DART SERVICE INSTRUCTION

TO AMEND INSTALLATION INSTRUCTIONS D206-559 REV. K OR EARLIER AND
INSTRUCTIONS FOR CONTINUED AIRWORTHINESS ICA-D206-559 REV. 2 OR EARLIER
REF. TCCA STC: SH92-17
REF. FAA STC: SH1031NE

A	NEW ISSUE		CP	10.06.30
REV.	DESCRIPTION		BY	DATE
DESIGN		DART AEROSPACE LTD		
DRAWN		HAWKESBURY, ONTARIO, CANADA		
CHECKED		DRAWING NO.	REV. A	
MFG. APPR.		DSI 9527	SHEET 1 OF 2	
APPROVED		TITLE	SCALE	
DE APPR.		BOLT CHANGE	NTS	
DATE		COPYRIGHT © 2010 BY DART AEROSPACE LTD		
10.06.30		THIS DOCUMENT IS PRIVATE AND CONFIDENTIAL AND IS SUPPLIED ON THE EXPRESS CONDITION THAT IT IS NOT TO BE USED FOR ANY PURPOSE OR COPIED OR COMMUNICATED TO ANY OTHER PERSON WITHOUT WRITTEN PERMISSION FROM DART AEROSPACE LTD.

FIGURE 4: TYPICAL CLAMPING DETAIL (D206-559)
FIGURE 32-3: TYPICAL CLAMPING DETAIL (ICA-D206-559)

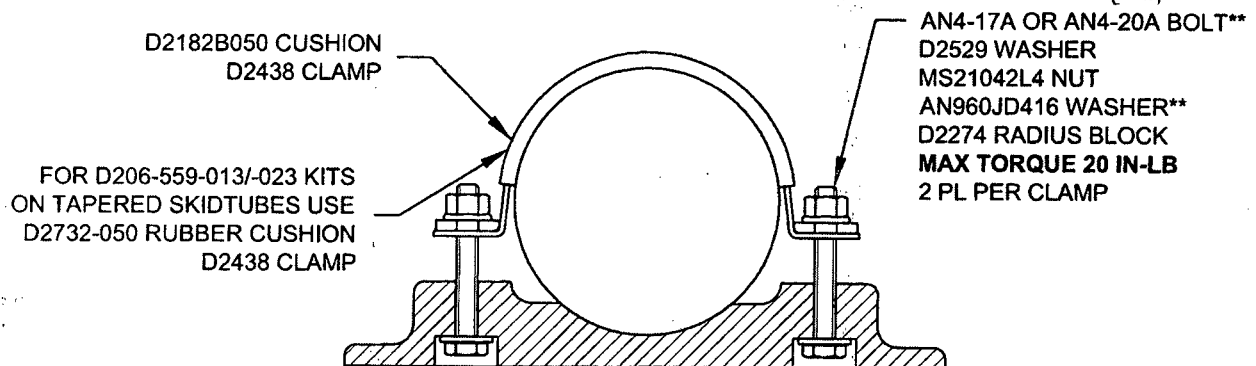
For D206-559-011/-013/-021/-023/-031/-033 bearpaw kits, the AN4 bolts specified were for installation with the aft skidtube wearshoe removed. Bolt lengths are increased to accommodate installation with the skidtube wearshoe installed, which is more practical.

Figure 4 of D206-559 and Figure 32-3 of ICA-D206-559 are amended as follows:

**USE AN4-17A BOLTS WITH AN AN960JD416 (OR NAS1149D0463J) WASHER IF INSTALLING BEARPAW ON 3.0" DIA. TUBE OR SMALLER. USE AN4-20A BOLTS WITH TWO AN960JD416 WASHERS IF INSTALLING BEARPAW ON TUBE LARGER THAN 3.0" DIAMETER (DART TUBE). ADDITIONAL AN960JD416 WASHERS MAY BE ADDED UNDER NUT TO ENSURE 2-4 THREADS IN SAFETY. IT IS ALSO ACCEPTABLE TO USE LONGER/SHORTER AN4 BOLTS IF REQUIRED TO ENSURE BEARPAW IS HELD SECURELY.
